Re: MM Docket 86-440

In re Applications and Amendments of)	MM DOCKET NO. 86-440
)	
Charlottesville Broadcasting Corporation)	File No. BMPCT-20031219AAK
)	
For Modification of Construction Permit)	File No. BMPCT-20030407AAM
For A New TV Station on Channel 19)	
At Charlottesville, Virginia)	File No. BPCT-19860410KP

Re: MM Docket 86-440, and application and amendment BMPCT-20031219AAK

Type:	ATW25H3H	
Directivity:	Numeric	dBd
Main Lobe:	25.00	13.98
Horizontal:	16.85	12.27
Beam Tilt:	0.75	
Polarization:	Horizontal	
Channel:	22	
Location:		
Note:	Figure 1.

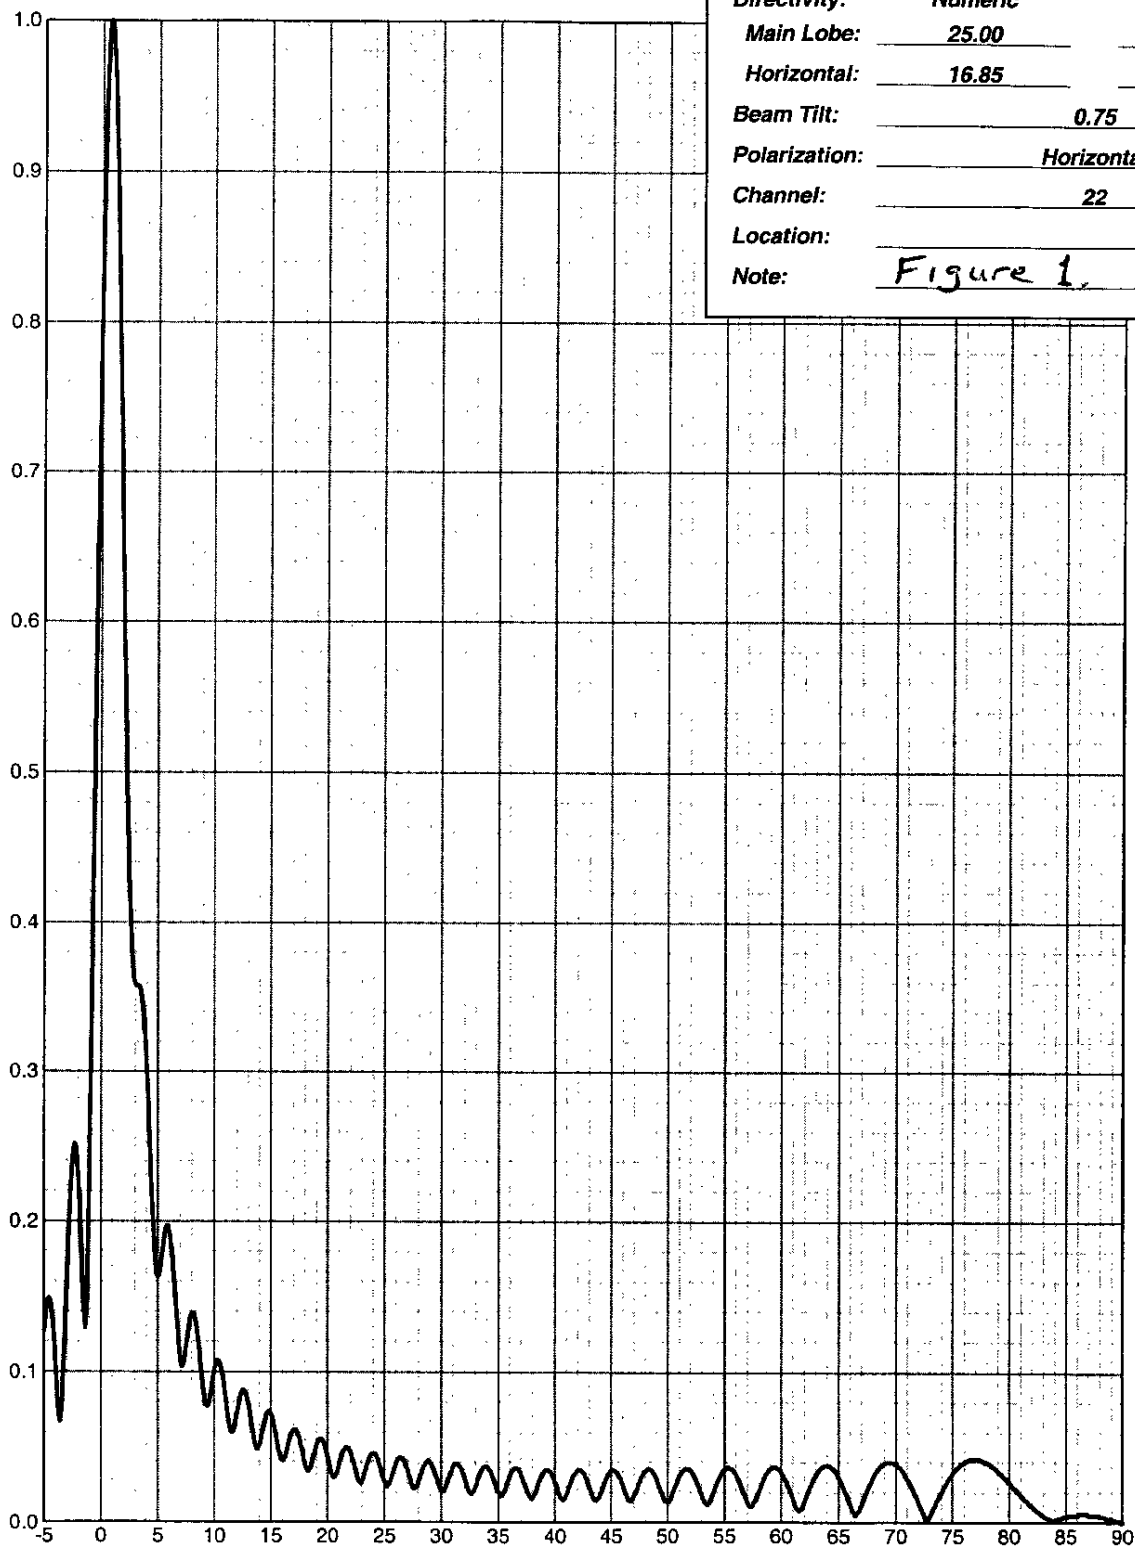
KWHY-TV is licensed to operate with a maximum ERP of 2,630 kW, on Channel 22. The KWHY-TV analog antenna is an Andrew Trasar, a top mount, UHF slotted transmission line design, mounted atop a 46.0 meter tall tower, ASRN 1036897, with a RCAGL of 55 meters. Utilizing Andrew Powertools™ software to duplicate the design of the KWHY-TV antenna, it appears to be equivalent to a model ATW25H3-HTC3-22H directional antenna with a special order, modified cardioid, horizontal pattern. The standard vertical pattern for this antenna is attached as Figure 1.

The look-down angle for this measurement point, from the KWHY-TV antenna radiation center (RC), is – 59 degrees. From Figure 1, the Andrew ATW25H3H vertical antenna pattern, we can see that the Relative Field factor, F, ranges from a high of .037 to a low of 0.010 within a range of plus and minus 2.5 degrees from –59 degrees.

Therefore, for a F of .037, the maximum predicted “S”, using CBC’s chosen OET Bulletin 65 methodology, is:

$$S = \frac{(33.4) * (.037^2) * (.4 * 2,630,000 + 263,000)}{(60.6^2)} = 16.4 \text{ uW/sq. cm.}$$

This is the maximum calculated “S” at the measurement point on the driveway adjacent to the Mt. Wilson Post Office that should have been obtained by measurement as predicted using the methodology utilized by CBC in their engineering report. It is less

than half of that which was measured by the Commission. If we also determine the minimum, based upon an “F” of 0.01, we obtain an “S” of 1.2 uW/sq. cm., or .0012 mW/sq. cm.

Therefore, the Commission, while measuring the RFR level along a 100-foot long section of the Mt. Wilson driveway, by calculation, should have obtained readings for KWHY-TV ranging from a high of .0164 mW/sq. cm, down to a low of .0012 mW/sq. cm, that is, from 46% down to 3%, of the actual RFR level measured.

If we reverse this calculation, and determine the “F” resulting from a “S” of .036 mW/sq. cm at the KWHY-TV site, we obtain a result of “F” = 0.055 .

What accounts for this difference? The KWHY-TV tower is adjacent to several taller towers, most notably the KMEX-TV tower, ASRN 1215107, and the KFTR-TV tower, ASRN 1232157; these towers are so close to the KWHY-TV tower that they share the same co-ordinates, when rounded off to the nearest second, in the FCC database. The KWHY-TV signal reflects off of these towers, scattering the signal in all directions, including toward the ground. The effect is similar to that found when the peak vertical pattern beam of a side-mounted, full power UHF antenna reflects off of the antenna’s mounting brackets, and supporting tower structure.
